THE MULBERRY HOUSE SCHOOL, SHOOT UP HILL, LONDON NW2 3XL

Report to the Planning Officer: Zenab Haji-Ismaail

20 May 2016

B PROPOSED AMENDMENTS TO PLANNING PERMISSION NO. 2015/5184/P

New front door and screen – etching on glass providing vision panels

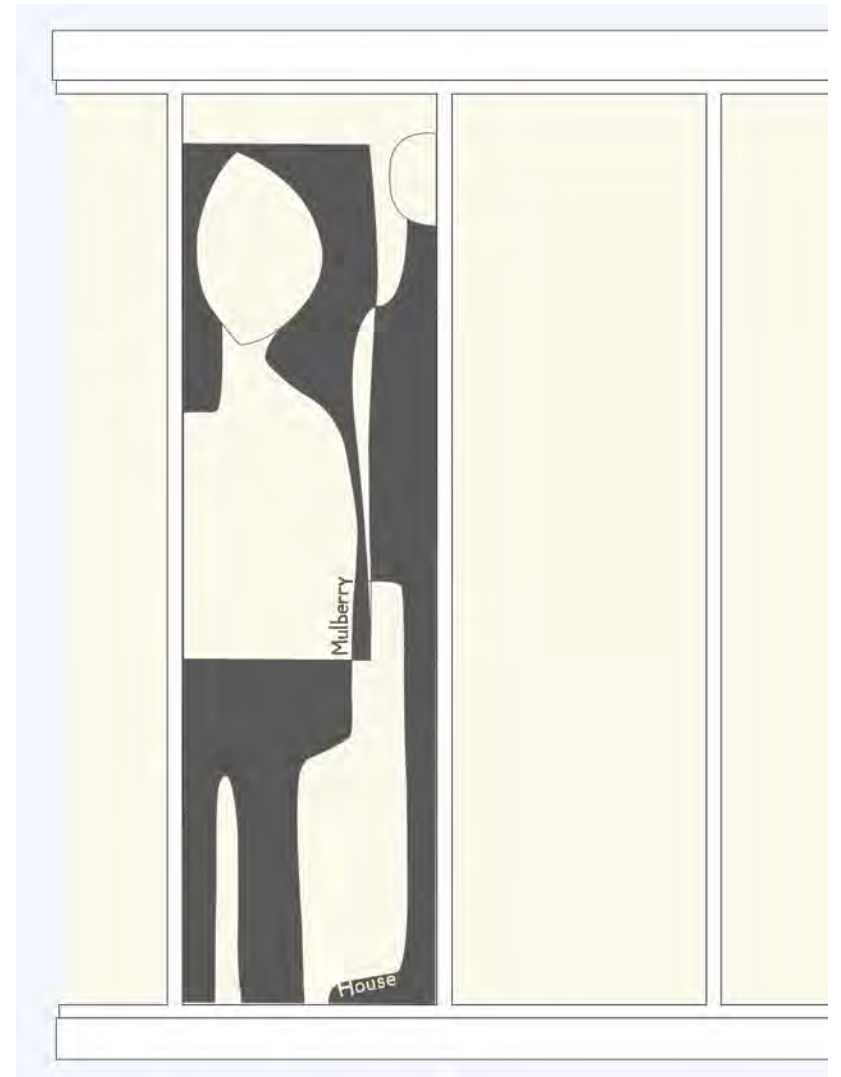
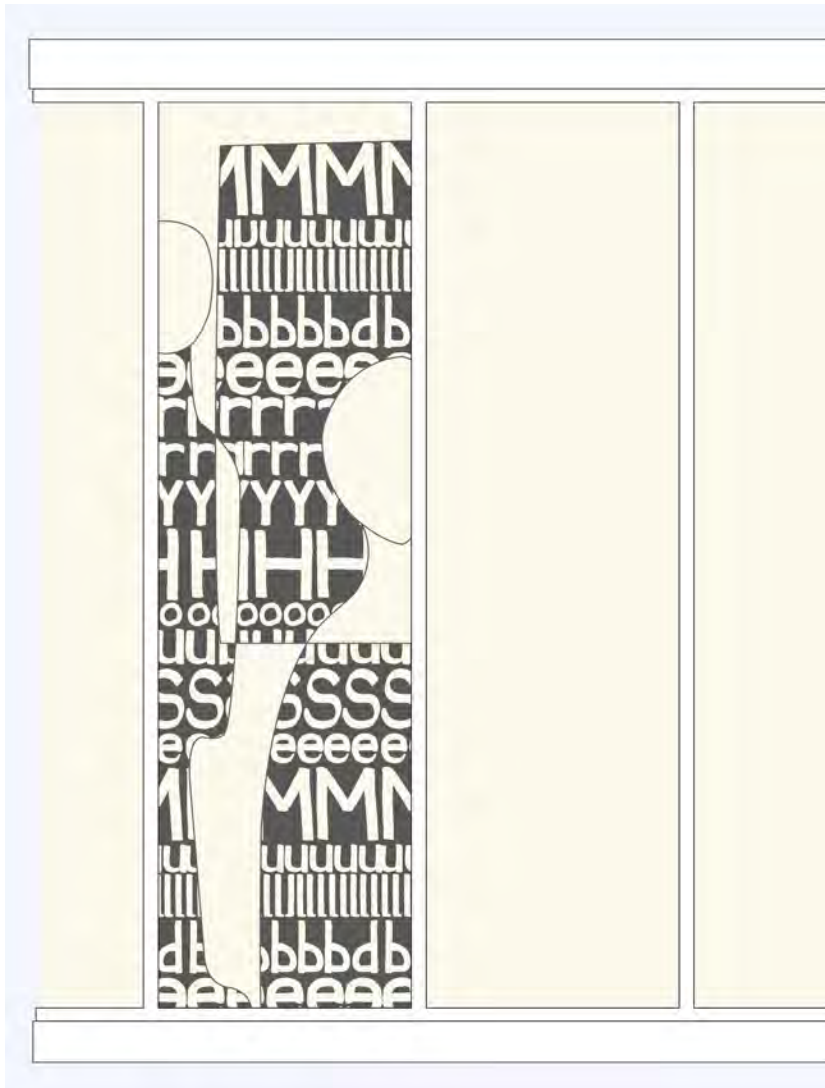
- 8 New front door screen and canopy**
To provide protection from weather, a canopy is proposed as a miniaturisation of the 'Cloud' roof over the roof play area. I attach drawing MUL-AC(3)7 illustrating this canopy and its generating geometry at page 13 of this report. A new front door to replace the – 'tired' – existing one is proposed. This will be etched in glass to the design found on page 14 of this report.

Two etched window panels – leftmost glass panel on Minster Road on the left – and leftmost glass panel on Shoot Up Hill on the right

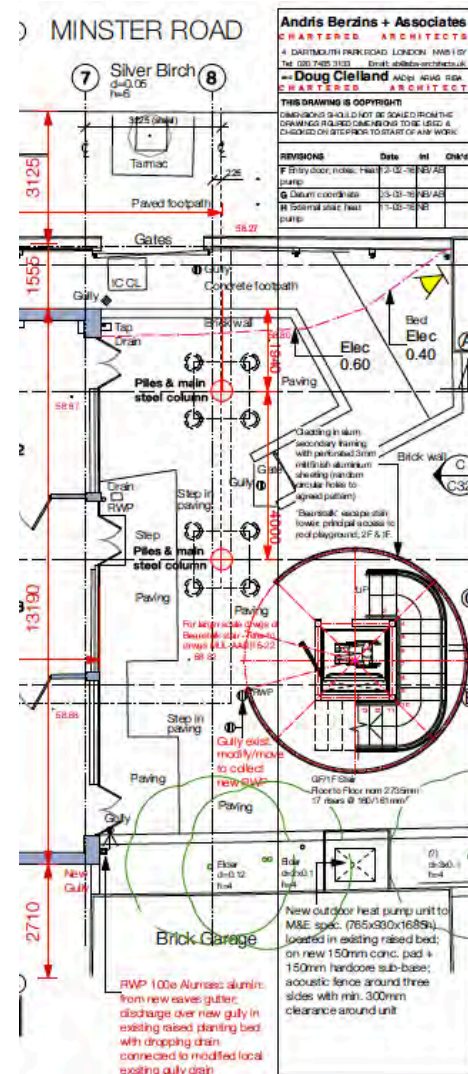
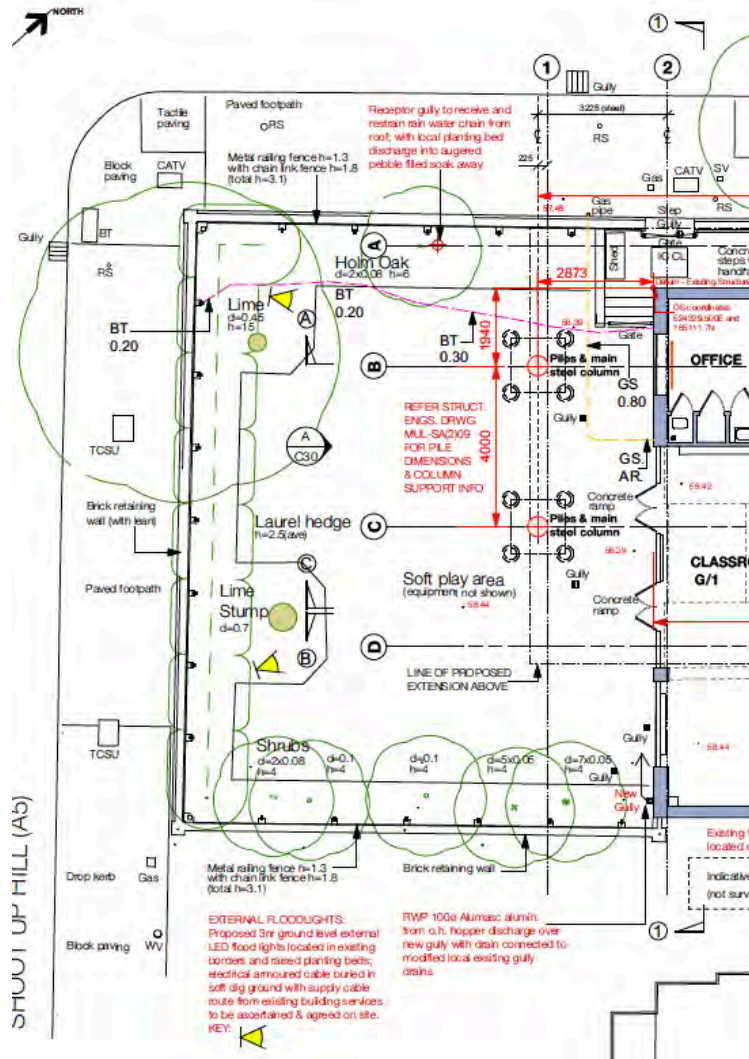
- 9 Two etched window panels**
The client wishes to subtly indicate that this is a school. Two of the translucent glazing panels therefore are proposed to have etched additions to the glass. One is on the furthest left panel of the Minster Road elevation (Elevation B) and the second is on the furthest left panel of the Shoot Up Hill elevation (Elevation A).
The proposals for these two panels are found at page 15 of this report.
